Review of the assessment of reliabilities for licences in the Tindall Limestone and Ooloo Dolostone Aquifers based on potential impacts on Daly River streamflows

Goyder Institute for Water Research
Client Report No. 16/1

Review report

Figure 4 Comparison of gauged and rated discharge at Dorisvale Crossing G8140067 (calculated using ratings relevant to the selected gauging period)

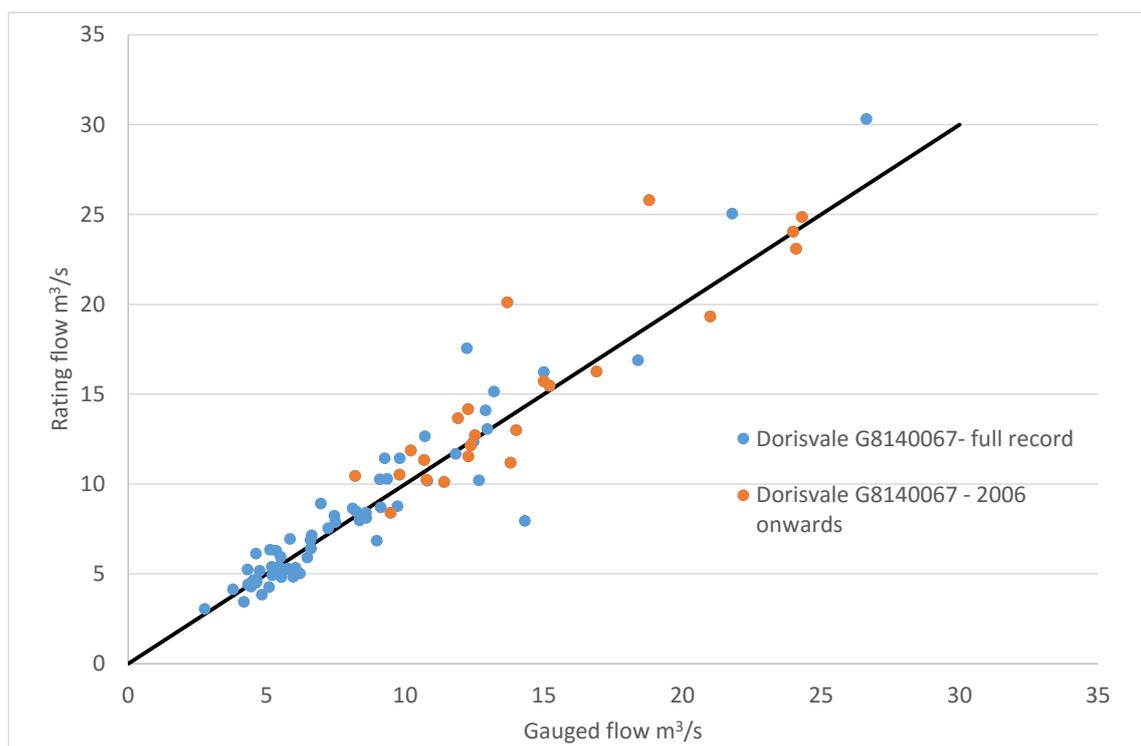
The impact at Dorisvale Crossing is assessed relative to the threshold discharge of 6.2 m³/s. Figure 4 compares gauged discharges against the equivalent discharge calculated from the rating curve for the site, from 1984 onwards. There are no recent gaugings of a similar magnitude to the Dorisvale threshold. Older values indicate an average error of approximately 11% for discharges within the range 4-8 m³/s, which is a typical level of error for a long-term site with a stable rating which is updated on a regular basis. There was no bias towards over or under prediction within this discharge range. This indicates that rating curves have generally been accurate in the past within this range, and the site is reliable as an estimate of discharges in the historical period.

However it is noted there have been no gaugings at the site below 8 m³/s since 1997, and a review of older gaugings indicates that the site has had different low flow – water level characteristics in the past. Figure 5 shows gaugings since 2004 (green), all older gaugings including those prior to 1984 (grey) and the current rating. While the current rating is consistent with the gaugings of 8 m³/s or above, there is no gauging confirming that the current rating below 8 m³/s is still valid. This is probably due to the wet climatic conditions in the catchment since the mid-2000's, meaning flows within this low range have been relatively rare anyway. However given the site has some history of variation in the rating at lower water levels, it is highly recommended that low flow ratings are carried out.

Figure 6 Comparison of gauged and rated discharge at Mt Nancar G8140040

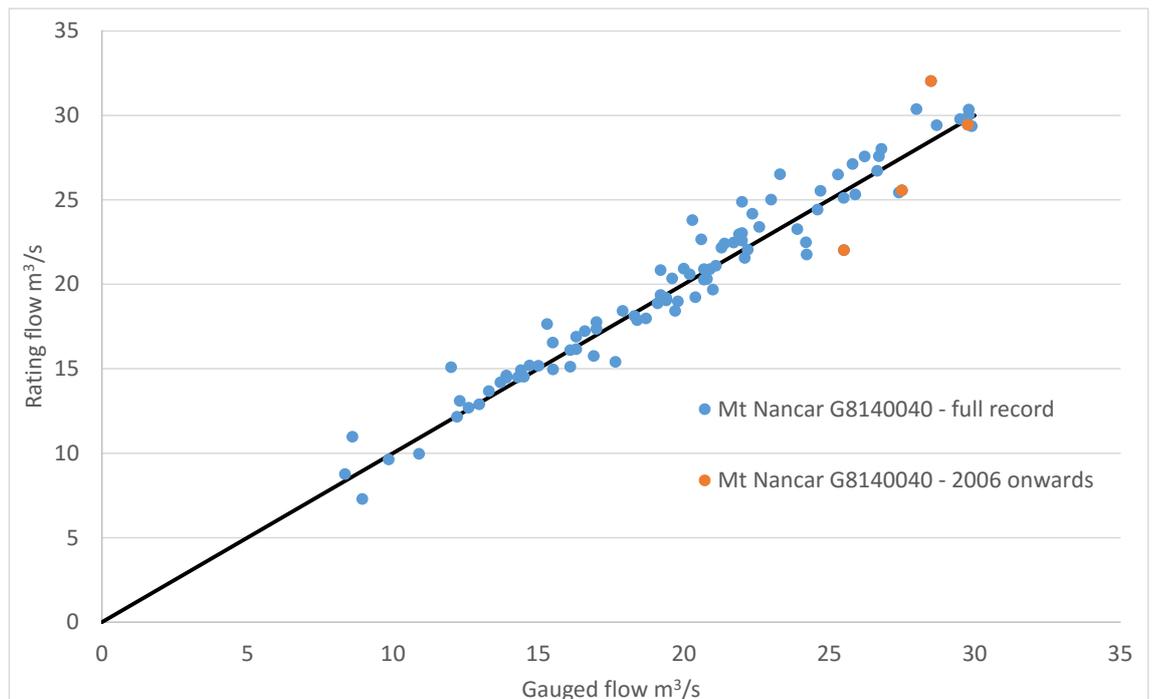
Similarly, the impact at Mt Nancar is assessed relative to the threshold discharge of 12.0 m³/s. Figure 6 compares gauged discharges against the equivalent discharge calculated from the rating curve for the site. As was seen for the Dorisvale Crossing site, there are no recent gaugings of a similar magnitude to the threshold. Older values indicate an average error of approximately 7% for discharges within the range 8-16 m³/s, which is a good level of error for a long-term site with a stable rating. There was a small bias (on average 5%) towards over-prediction by the rating curve within this discharge range. This indicates that rating curves have generally been accurate in the past within this range, and the site is reliable as an estimate of discharges in the historical period.

Again, as was seen at the Dorisvale Crossing site there have not been low flow gaugings since 2006, probably due to the wet climatic conditions and higher dry season flows since the mid-2000's. Consequently it is unknown whether the current rating curve is accurate for low flows and this should be investigated.
